TO: Variation 3 Team, City Development

FROM: Trevor Watson, Reese Martin, and Ian Martin, DCC Transport Strategy
Peter Hughes, DCC Network Asset and Funding

DATE: 20 August 2024

SUBJECT: **TRANSPORT COMMENTS ON 2GP VARIATION 3 – MINOR IMPROVEMENTS CHANGE PROPOSALS**

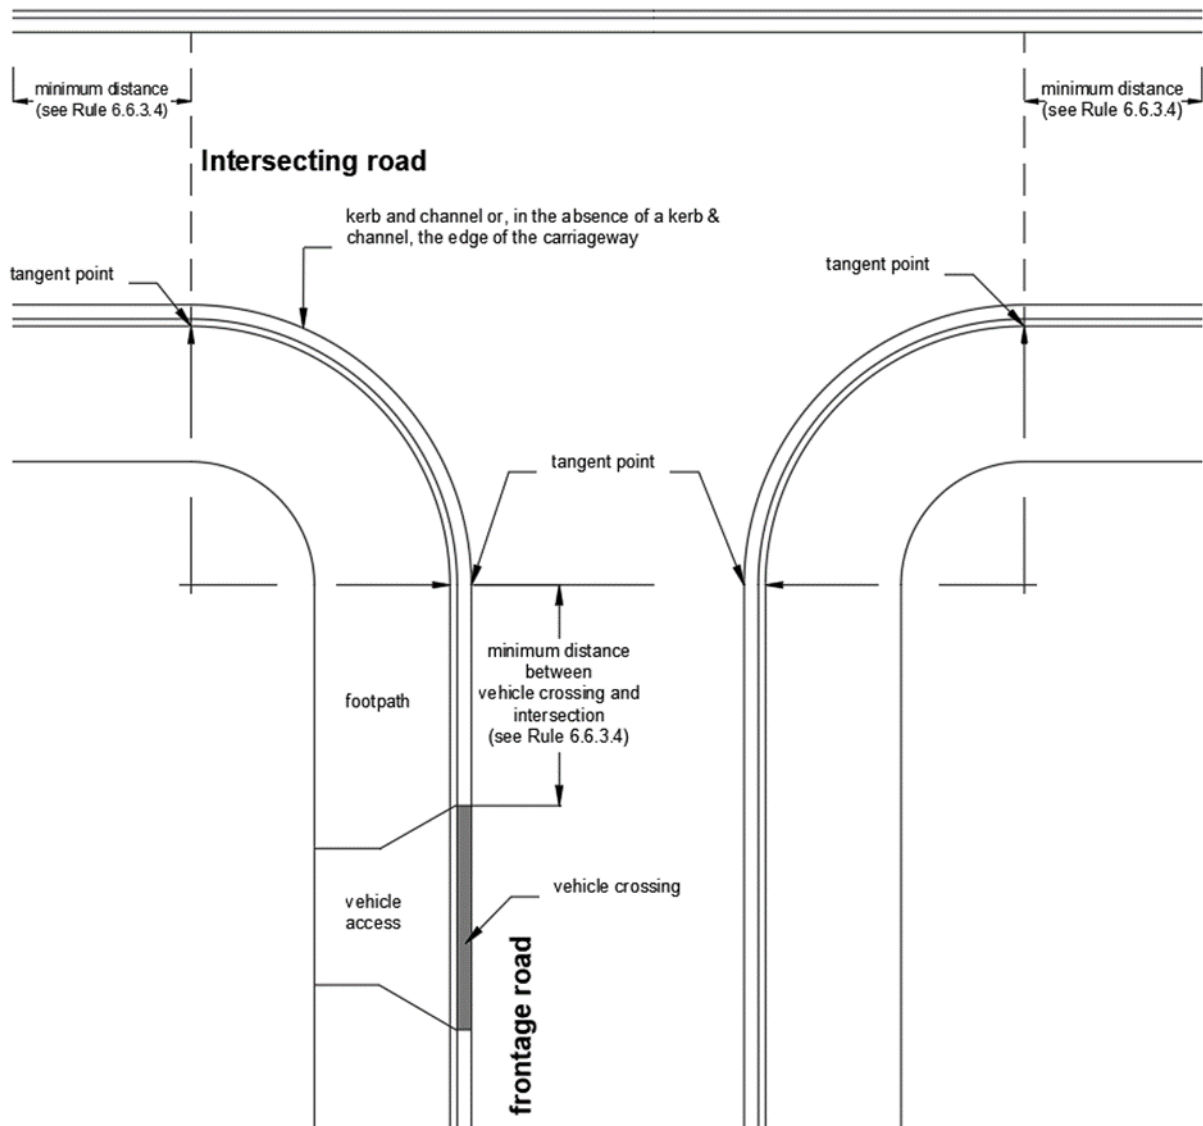
48. In reference to the above, a further difficulty has also been identified around the functionality of Figure 6B.17. This existing figure does not adequately show how minimum distances should be measured from a new vehicle access near "T" junctions. This is of particular concern when a new vehicle access is proposed directly opposite to the lower intersecting road, effectively creating a crossroads intersection and has the potential to create road safety concerns. The implications would be dependent on the surrounding environment and should therefore be subject to assessment where a rule breach has been identified.

49. Therefore, it is recommended that Figure 6B.17 should be amended to also include how the requirements of Rule 6.6.3.4 should be measured in instances where proposed vehicle accesses are sited directly opposite a "T" junction to better inform both plan users and DCC staff on how this requirement should be interpreted and acted upon. The proposed updated diagram for Figure 6B.17 in Appendix 6B is as follows:
